Georgetown Charter Township

Planning Commission Meeting Agenda

SITE PLAN
WW GREENHOUSES
4044 CHICAGO DR.

SITE LAYOUT + UTILITY PLAN
6555 CENTER INDUSTRIAL DRIVE

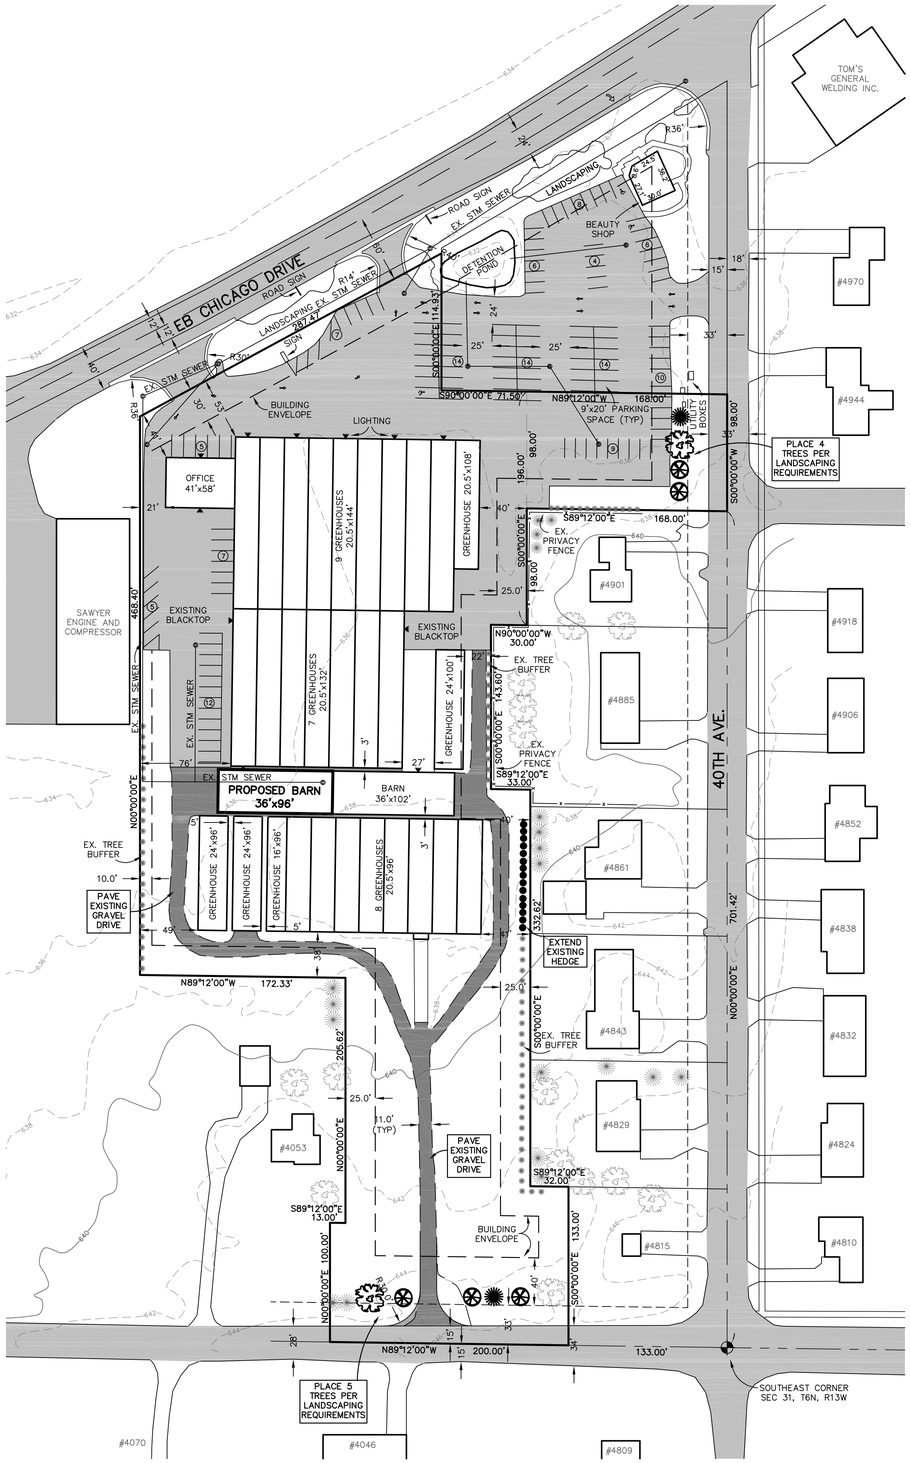
1) The front yard setback is required to be 30 feet from the property line. Chapter 24 footnote l states that the required front yard setback (30 feet) shall be landscaped and not used for parking or drives. L**andscaping and landscaping calculations along Chicago Dr. and 40th Ave. were provided.**
2) The side yard setbacks are 10 and 15; however, the Planning Commission will determine if the requirements are met in Sec. 26.3(D) for a greenbelt for a parking area adjacent to a residential district. The adjacent property to the east and south is all LDR and the 25 foot greenbelt is required. **Landscaping calculations were provided.**
3) The rear yard meets the requirement to be 40 feet. **Landscaping or the greenbelt along New Holland was provided.**
4) **The building at the corner of Chicago Dr. and 40th Ave. is not included in this proposal.**

As per the plan, landscaping and greenbelt calculations were provided for along Chicago Dr., 40th Ave. and New Holland. Some additional landscaping is proposed; however, the plan shows that much landscaping already exists. The applicant is asking for the Planning Commission to determine that the existing landscaping meets the ordinance requirements for streetscape and for greenbelts.

b. Lot coverage was provided and meets ordinance requirements since a variance was granted in 1988.

c. The driveway is noted to be paved.

e. Sign and lighting details were provided. They currently exist and no changes are proposed.

f. As per the parking calculations, 74 spaces are required and 61 spaces are provided on the site and an additional 60 are shared from the neighboring site.

h. **A Storm Water Drain permit (written approval) from the Ottawa County Water Resources Commissioner's office will be required at the time a Zoning Compliance/building permit application is submitted**.

drained so as to dispose of all surface water. **Variance granted for northern section only. A hard surface for the southern driveway is noted on the plan to be provided.**

(8) All lighting shall be shielded from adjacent residential areas. **Lighting is noted on the plan and appears to meet this standard.**

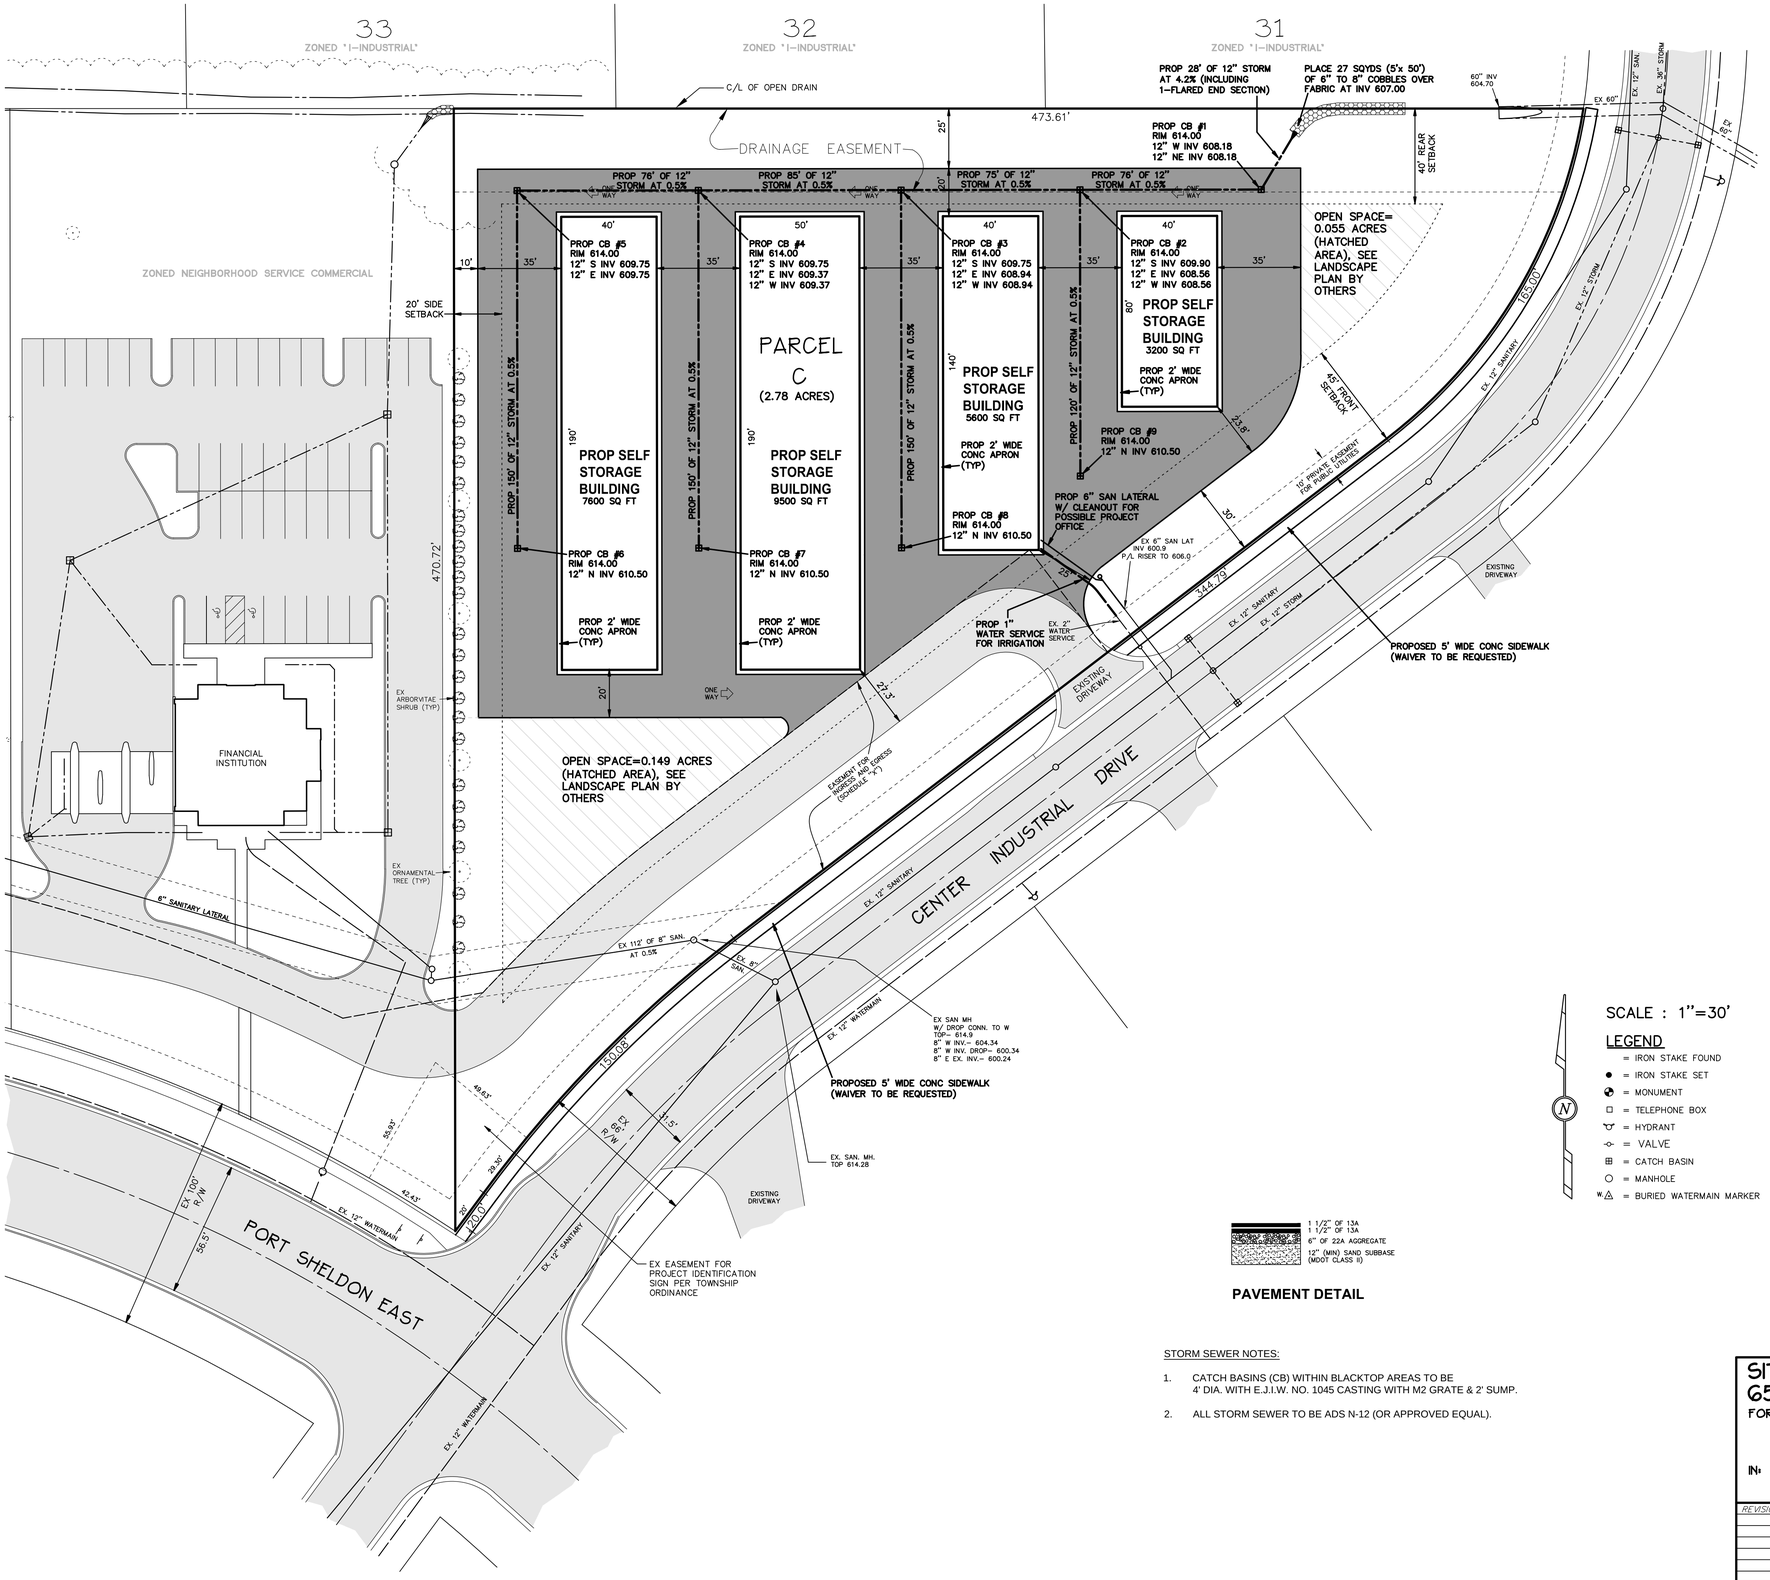
5. **Open Space.** A total of 0.21 acres of open space is proposed, which is 7.5%, less than the 20% that is required**.** Ten evergreens are proposed to be planted on a berm in the open space. **The determination is that the proposal _____ (does or does not) meet the ordinance requirements for open space.**

The parcel is 2.78 acres and 20% is 0.56 acres. The plan shows 0.06 acres of open space at the northeast corner and 0.15 acres at the south corner for a total of 0.21 acres which is 7.5%, less than what is required. Even if the open space is not set apart for "active" usability, it could be set apart for "passive" usability such as for detailed and extensive landscaping. Nothing has been provided indicating what will be in these areas. Landscaping is provided in the open space (10 evergreens). The Planning Commission and Township Board will determine if this proposal meets the ordinance.

PROVIDED; however, the Planning Commission and Township Board will have to determine if the amount is acceptable. Landscaping (10 evergreens) is shown within the open space.

None are provided within the site and a waiver is requested from the Board to eliminate the requirement of sidewalks along Center Industrial Dr. The Planning Commission and Township Board will have to determine if the amount is acceptable.

Styles NOT PROVIDED but a note on the plan indicates that lighting poles will be a maximum of 25 feet tall and will be downward directing.

The following is the Future Land Use Map related to the proposed PUD development.

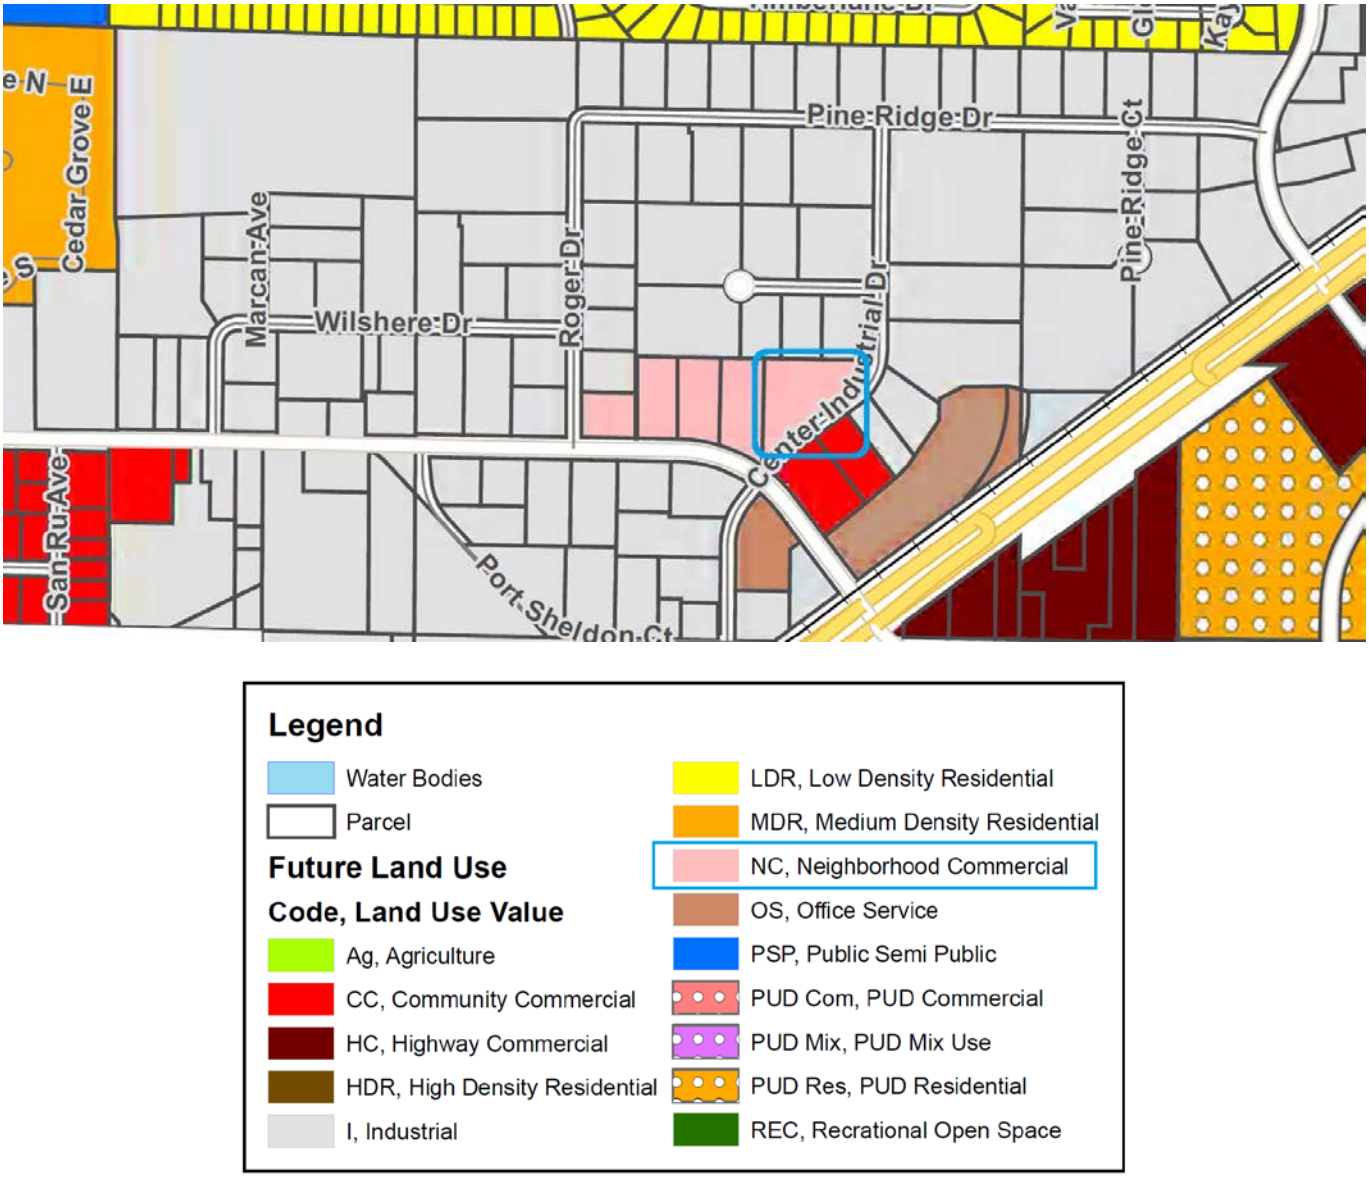
The Planning Commission will determine if this standard is met. The Future Land Use Map designates the parcel to be NC (Neighborhood Commercial). However, the site is adjacent to the Industrial designation and page 35 of the Master Plan states that the lines separating use categories are NOT to be considered as defined line and are not necessarily parcel specific.
